CITY OF FORT LAUDERDALE

# DEVELOPMENT REVIEW COMMITTEE

CASE NO. UDP-S23071

<b>CASE:</b>	UDP-S23071
<b>MEETING DATE:</b>	January 23, 2024
<b>REQUEST:</b>	Site Plan Level II Review: 9-Unit Townhouse Development
<b>APPLICANT:</b>	17th Way Development, LLC.
<b>AGENT:</b>	Patrick O. Soares, Studio Patrick Soares, LLC.
<b>PROJECT NAME:</b>	The Nine at Progresso
<b>PROPERTY ADDRESS:</b>	929 NE 17th Way
<b>ZONING DISTRICT:</b>	Residential Multifamily Mid Rise/Medium High Density District (RMM-25)
<b>LAND USE:</b>	Medium-High Residential
<b>COMMISSION DISTRICT:</b>	2 – Steven Glassman
<b>NEIGHBORHOOD ASSOCIATION:</b>	Victoria Park Civic Association
<b>CASE PLANNER:</b>	Tyler Laforme

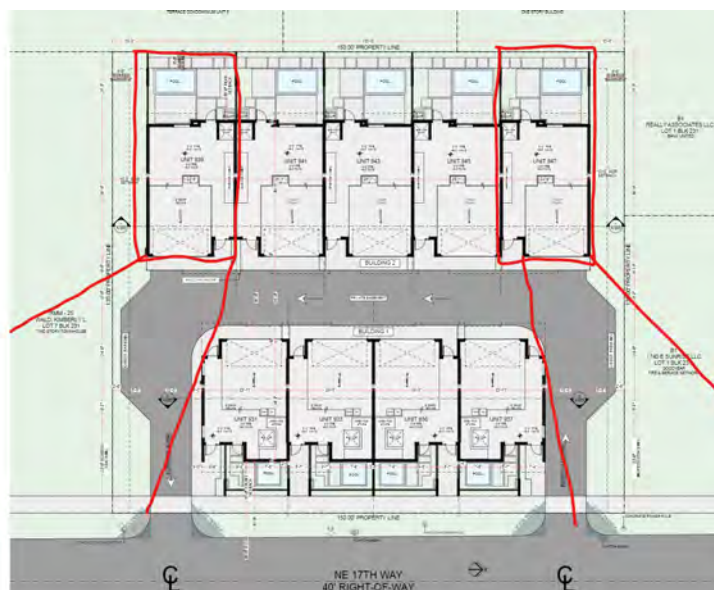
- 7) Provide the following changes on the rooftop.
  - a. The elevator and stair shaft cannot open into any type of room other than a landing and door. Currently the room shown for Building 1 is too large on the rooftop. Building 2 rooftop circulation landing is the correct layout, or it could be double the size for a landing for stair and elevator if not accessing at the same point.

- b. The walls separating the individual rooftops can be no higher than 42 inches above the habitable rooftop height of 35 feet. See below image:

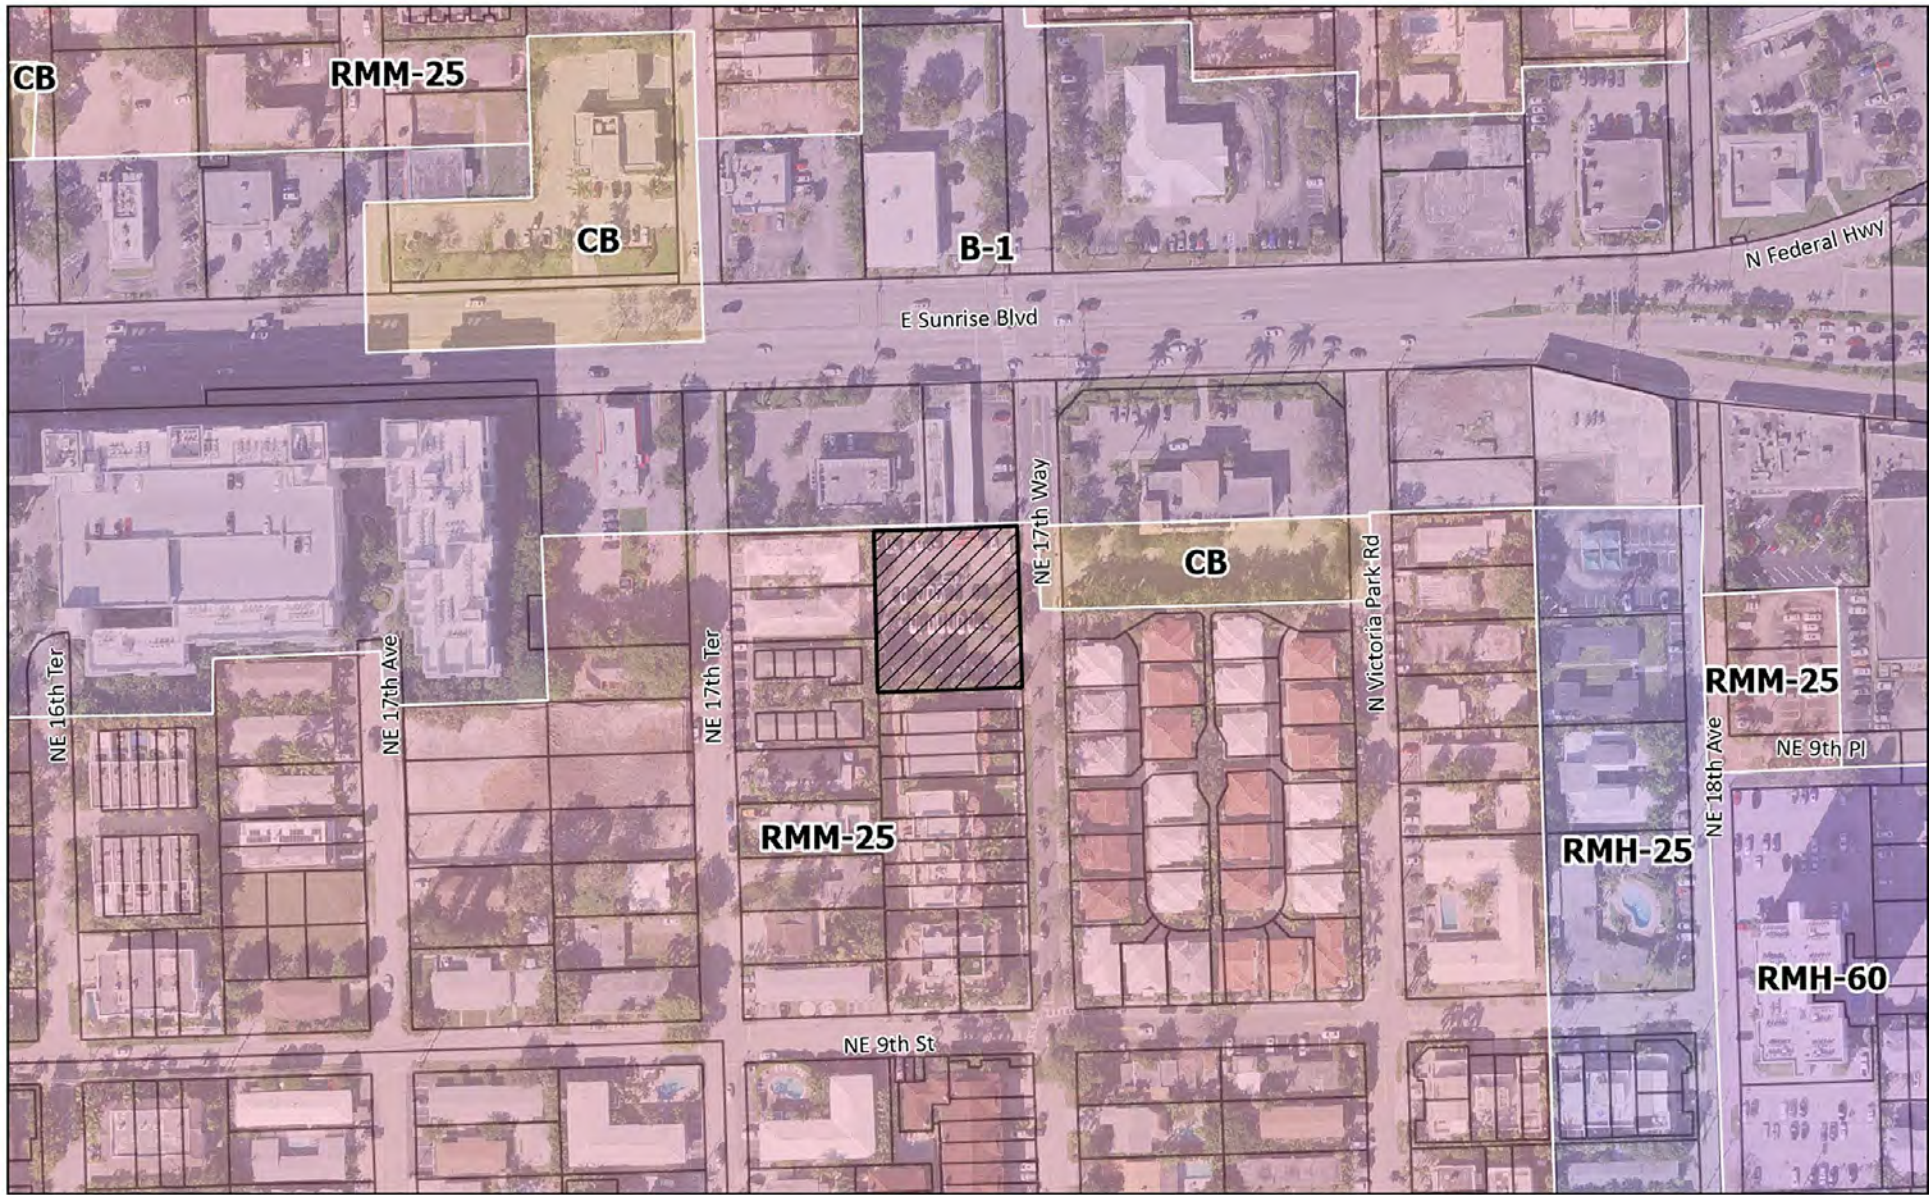
- 11) Pursuant to ULDR Section 47-18.33.B.11, Townhouse Garage design criteria, garages facing the public right-of-way are subject to additional requirements. The below image shows the units that would be subject to these requirements.
